TO: All Bidders May 19, 2020
FROM: Janice Kisch, Purchasing Specialist
SUBJECT: Bid 537 Ventura College Learning Resource Center Chiller Replacement

Bid 537 Ventura College LRC Chiller Replacement – ADDENDUM 1

- A. Replace M1.0 with M1.0 Addendum 1 dated 5-14-20
Added Factory Supplied Circuit Breaker
- B. Replace M2.0 with M2.0 Addendum 1 dated 5-14-20
Revised piping and electrical notes
- C. Replace M2.1 with M2.1 Addendum 1 dated 5-14-20
Added detail 5
- Replace M3.0 with M3.0 Addendum 1 dated 5-14-20
Revised butterfly valve style

2
M2.0
MECHANICAL ROOF PLAN
SCALE: 1/4"=1'0"

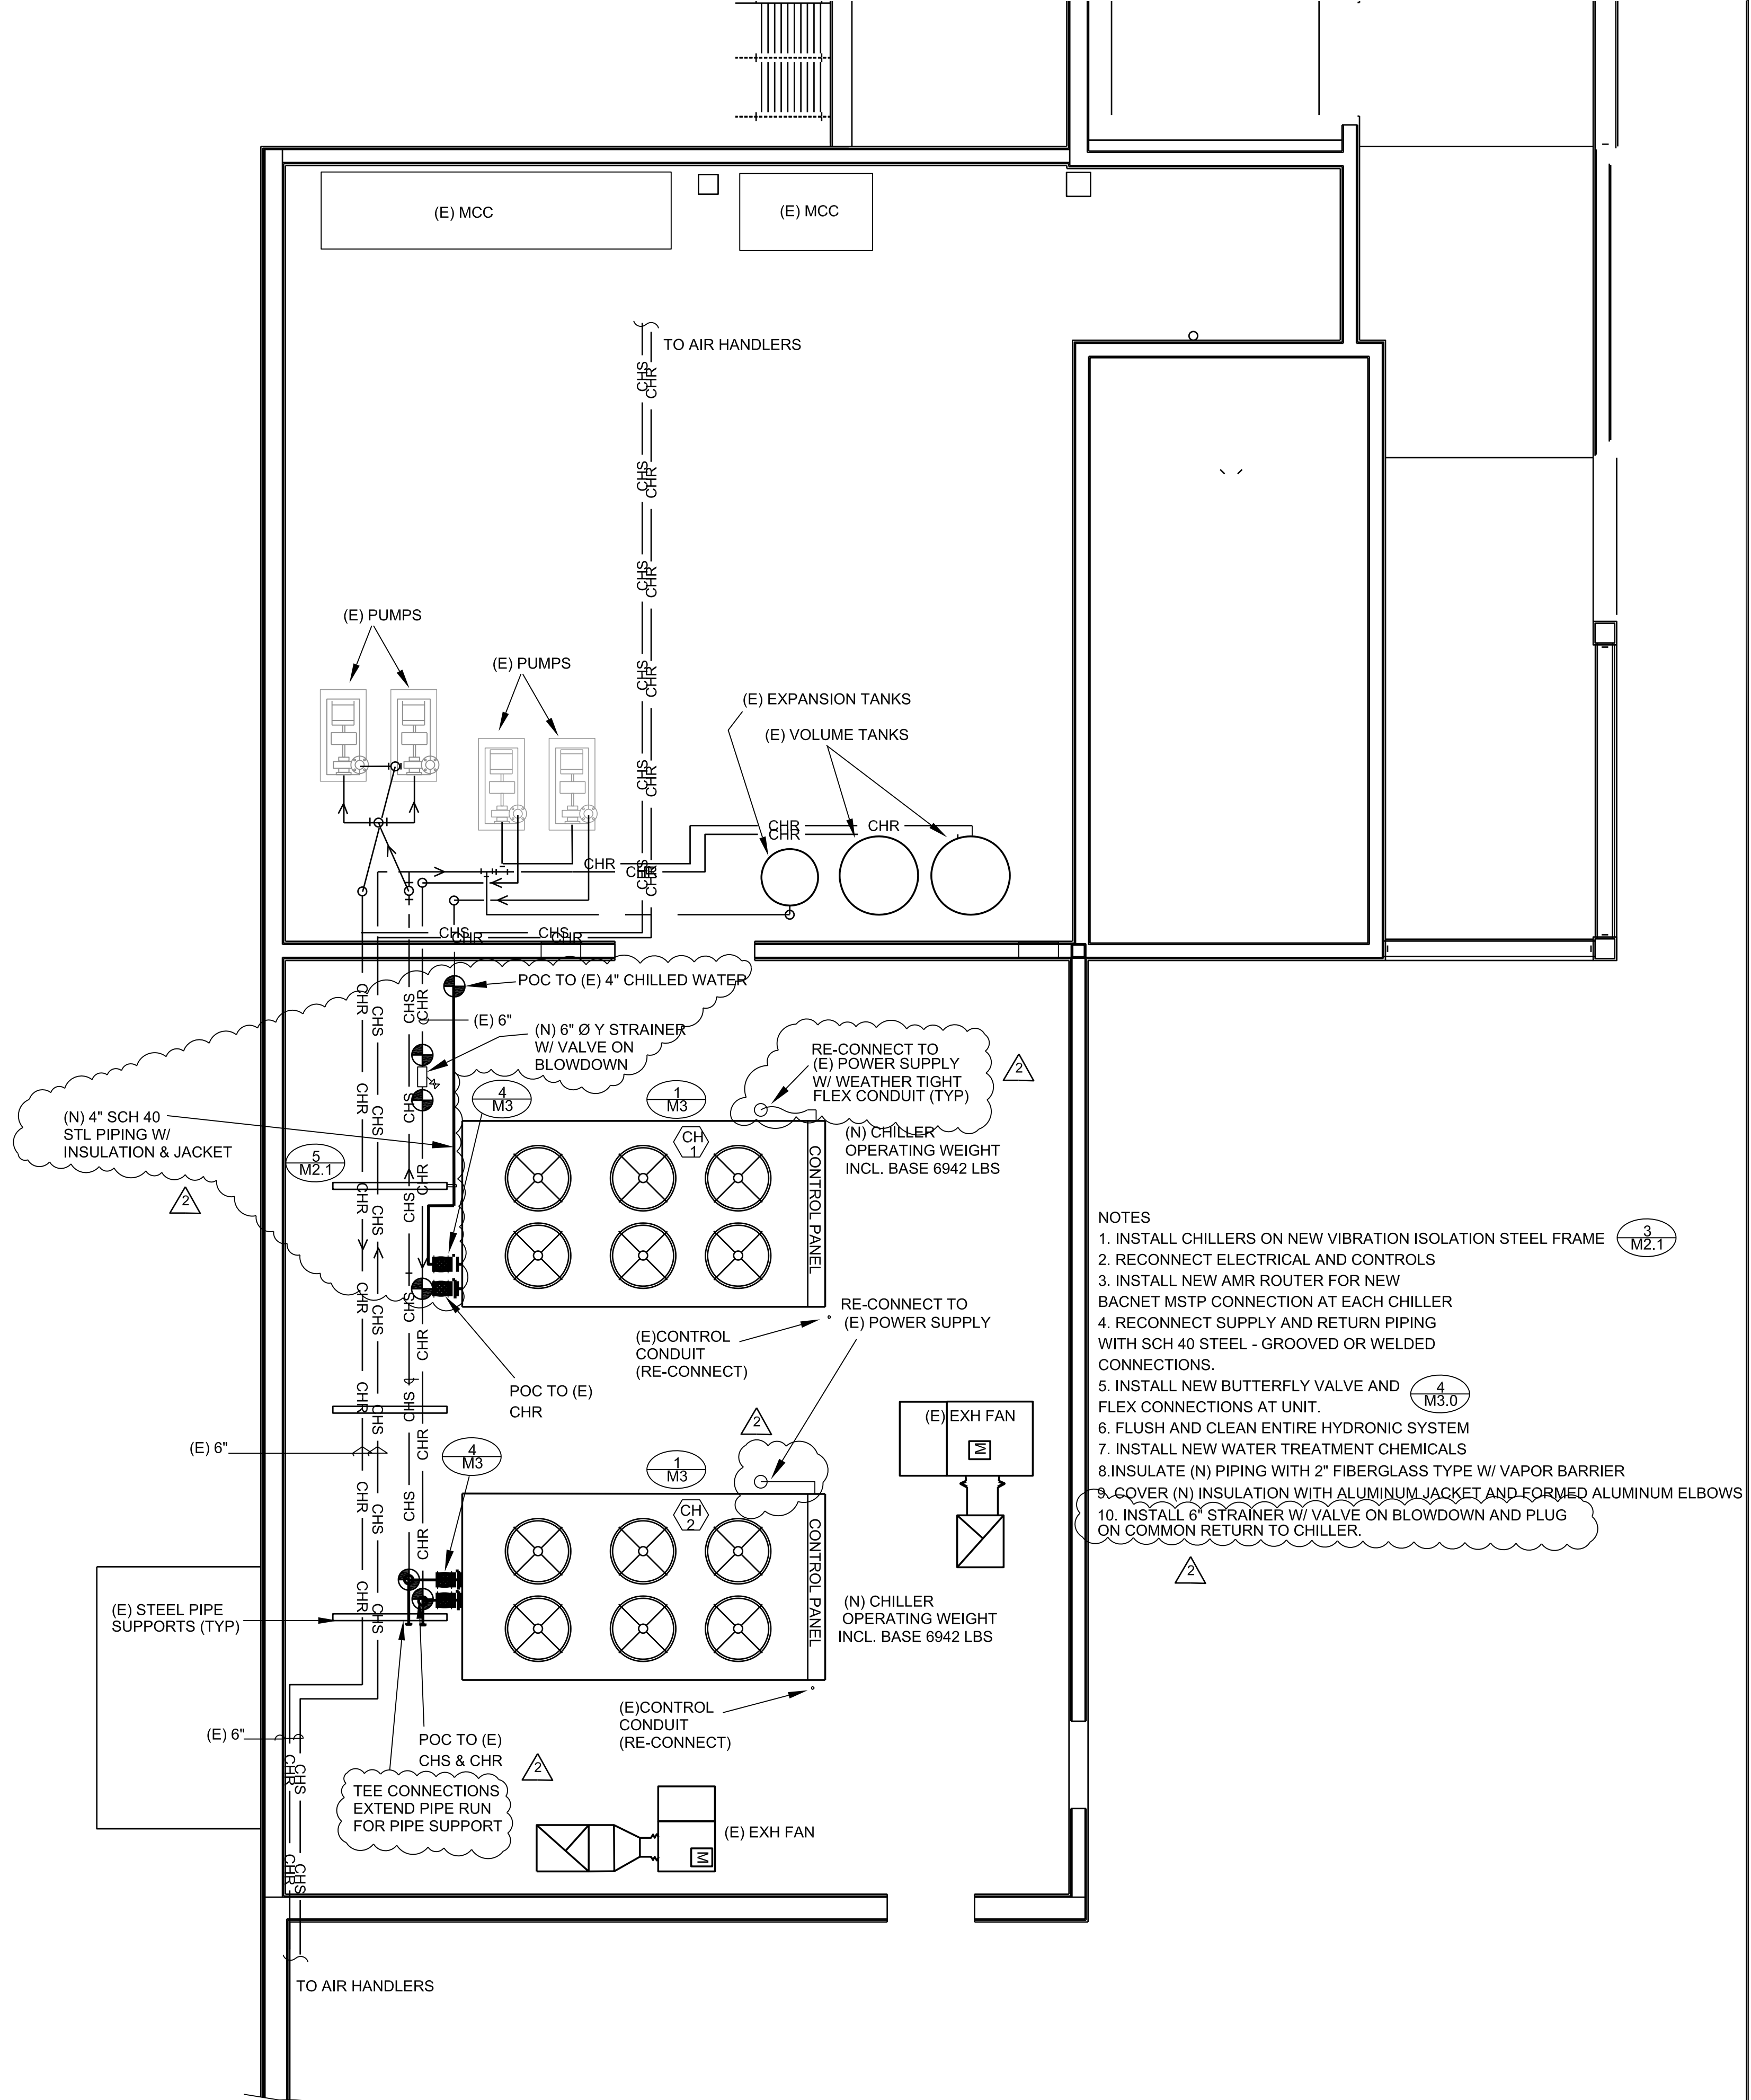
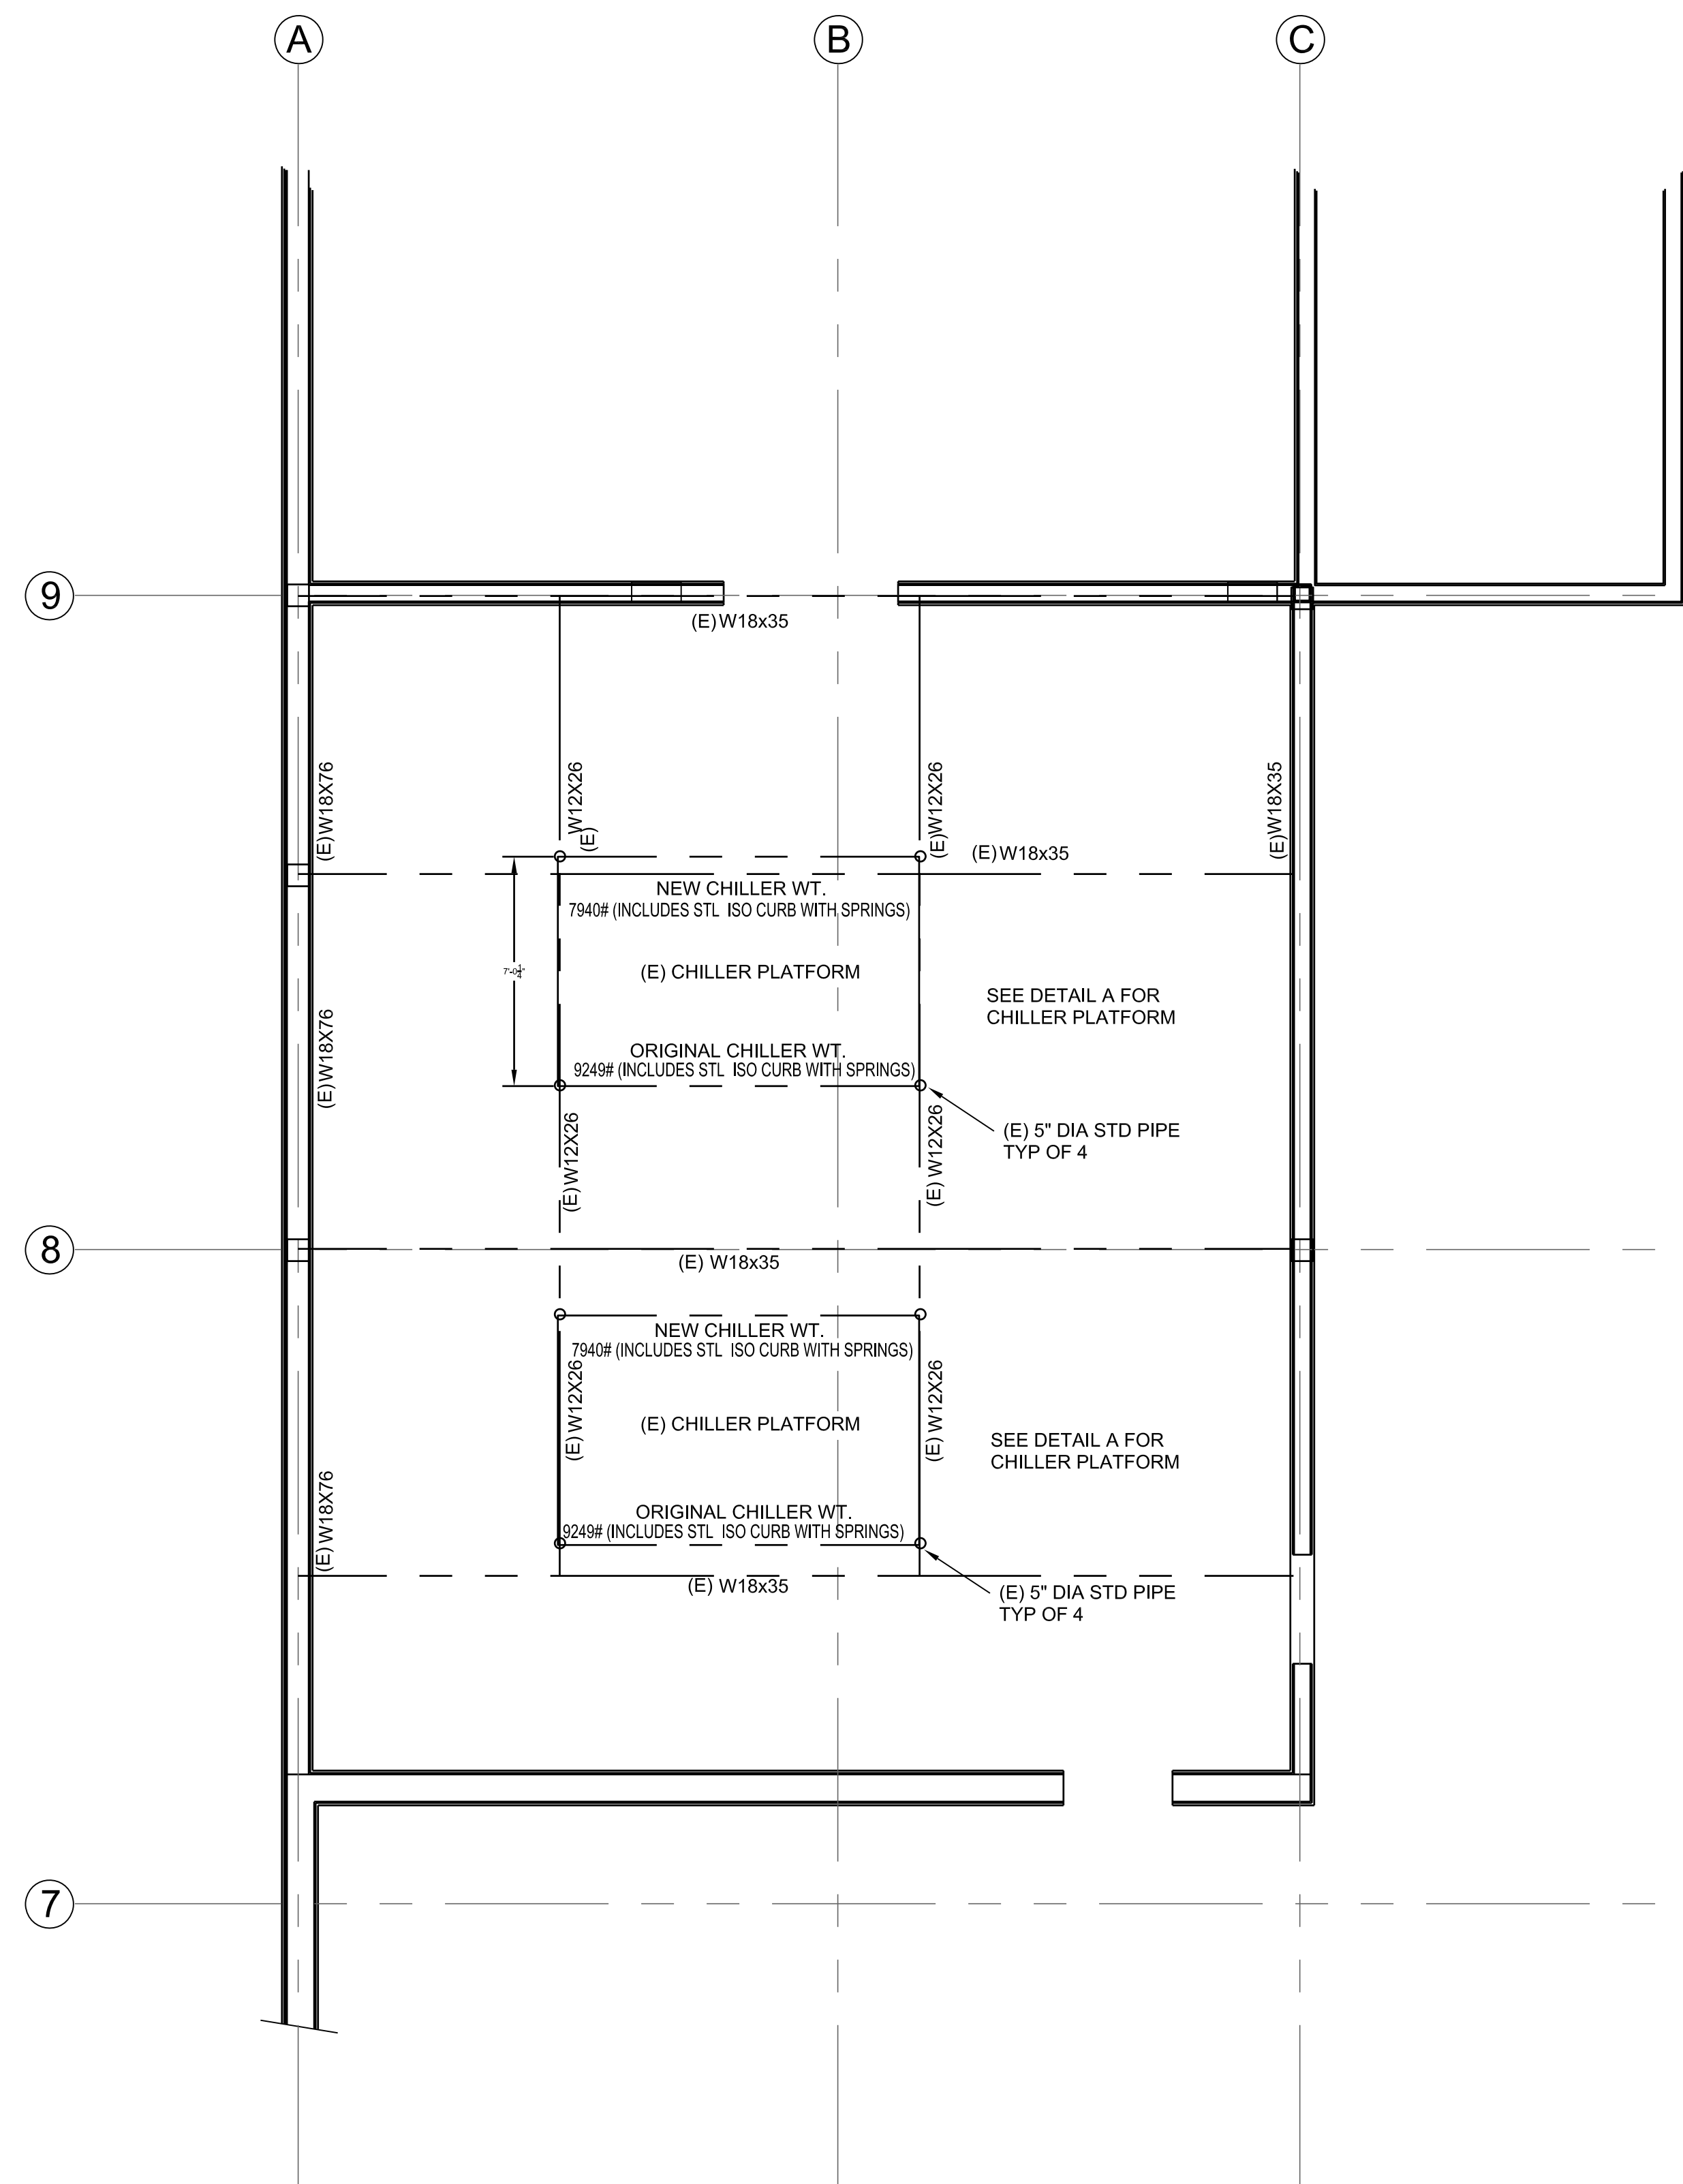
Question #3 Pipe arrangement on prints doesn't match what's on site.

On chiller #1 it shows CHWS going through the back of chiller when in reality it goes under the chiller. What's the actual POC?

The prints show CHW pump discharge on both are piped to chiller #1?

Answer – The new piping connections are at the back of the Trane chiller. There is a common supply that branches to each chiller that shall be adapted to the new arrangement. Each chiller has dedicated supply piping to their respective primary pumps. New piping is required from chiller to point of connection to the existing piping. See P2.1 Addendum 1 (delta 2)
